Re: Plot 11/6 M.M.I. Machinman Q.

BUILDING SURVEYOR'S REPORT.

With reference to your application dated 5-8-36
with a plan for the proposed building/additions and alterations on plot
No. 11/6, Survey Sheet No. M.M.I. Machi M Quarter
I have to request you to comply with the following requirements:—

PROPOSED BUILDING ON PLOT NO 11/6 MM.
MACHHIMIAHI QUARTER
SCALE 8"=1"

PROPOSED BUILDING ON PLOT NO 11/6 M.M.I.
MACHHIMIAHI QUARTER
SCALE 2"=1"

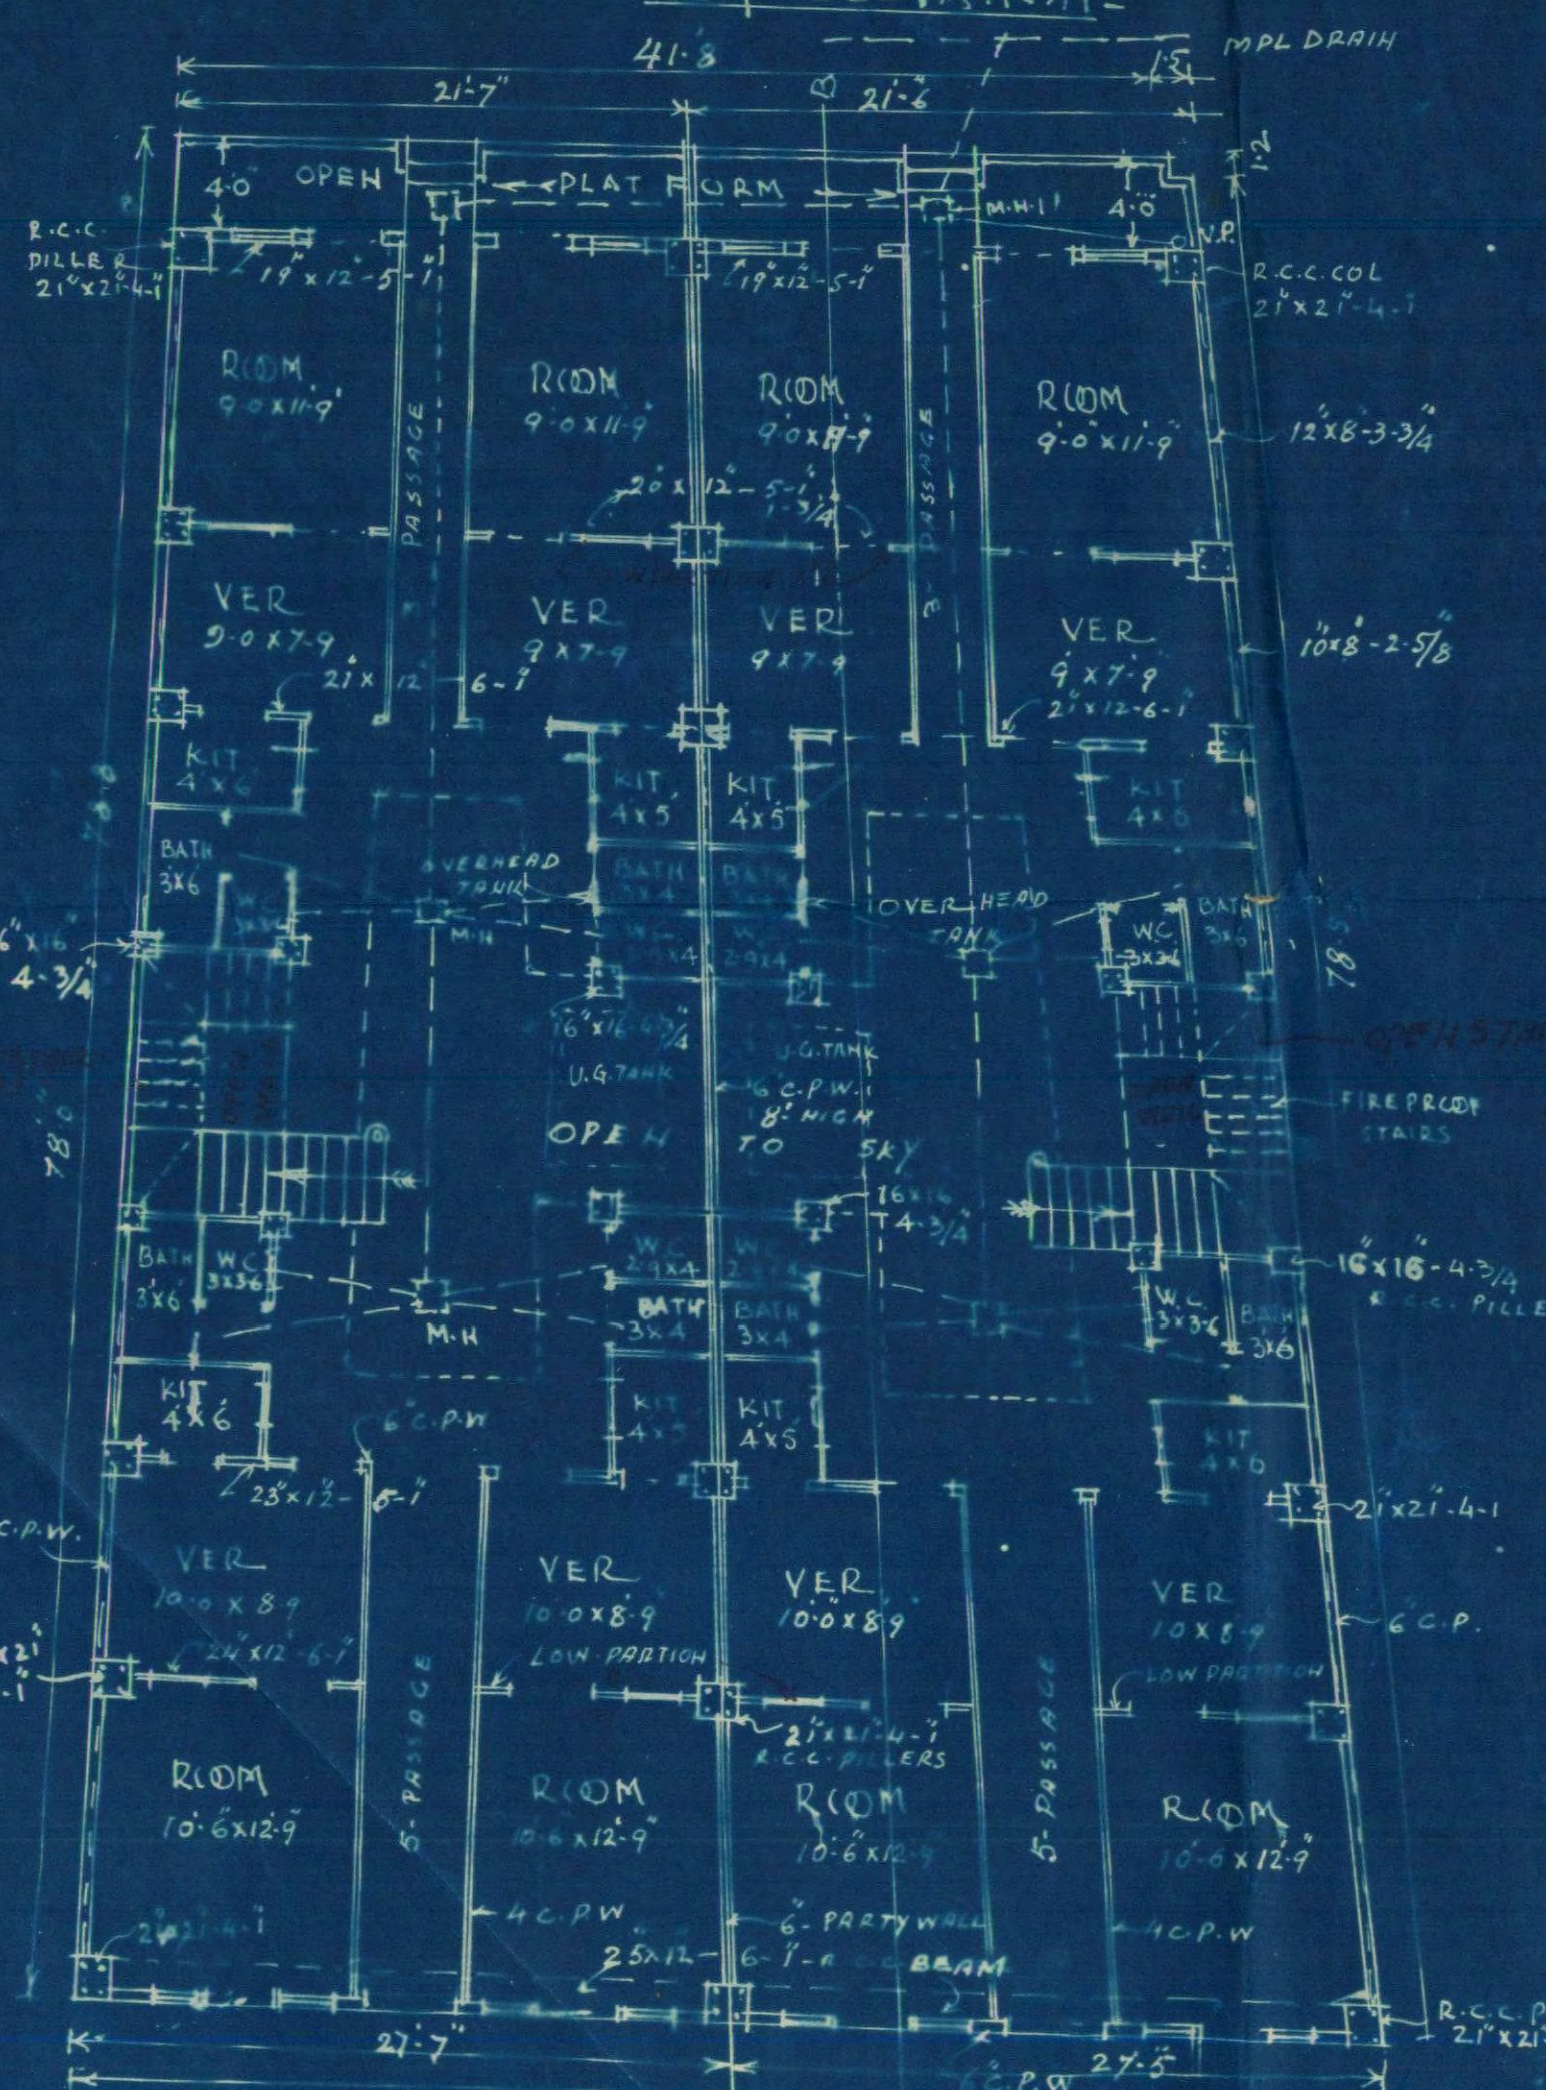
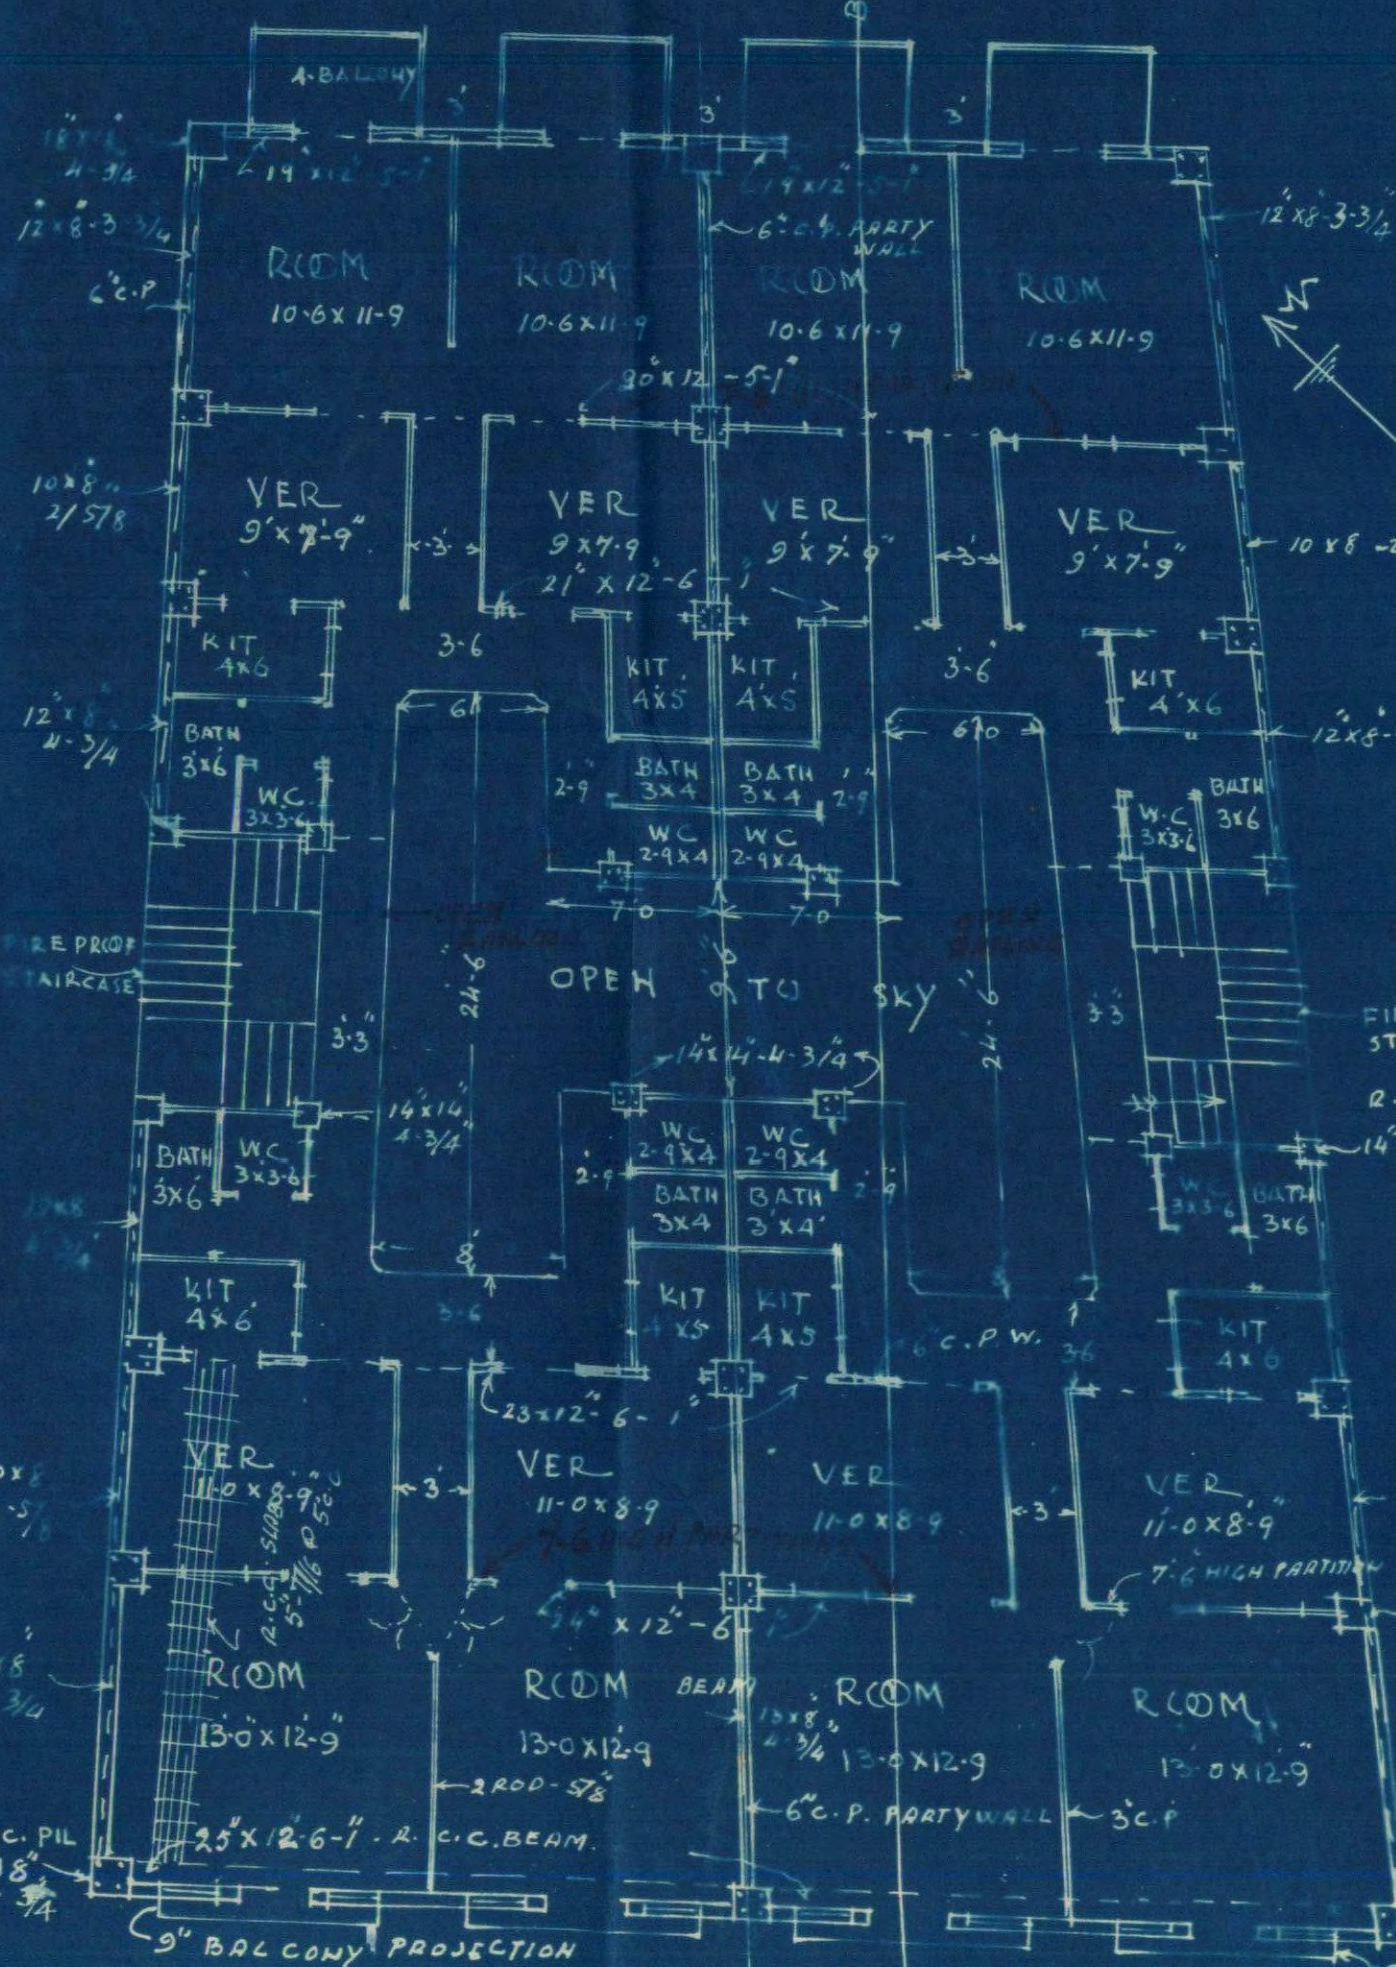
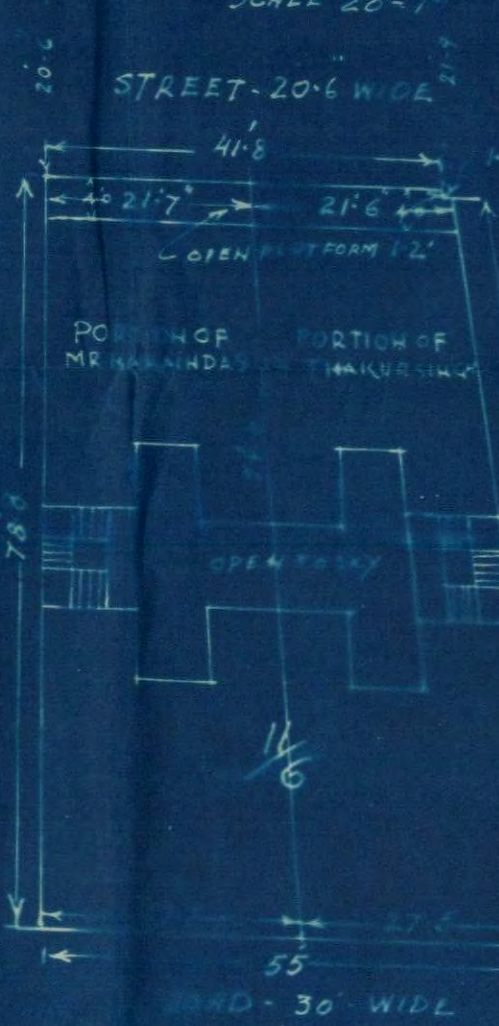
Width of the internal open space is not sufficient for
the proposed height.

The internal open space between outhouses blocks has been increased from 9'-6" to 12'-0", which now gives the entire width of plot say 12' as open space except two open staircases at ends. The veranda and outhouses for which the open space has been provided will be well lighted and ventilated.

Reside as stated in my letter dated 20-8-36 the partitions between the front rooms abutting on roads and verandas abutting on internal open space will be kept 7'-6" high only for better ventilation and light. Under the circumstance the objection should please be waived and plans may be approved.

The internal open space has now been increased from 9'-6" to 12'-0". Further as stated by the architect the partition walls between rooms and verandas have been proposed only 7'-6" high. As per requirement remains
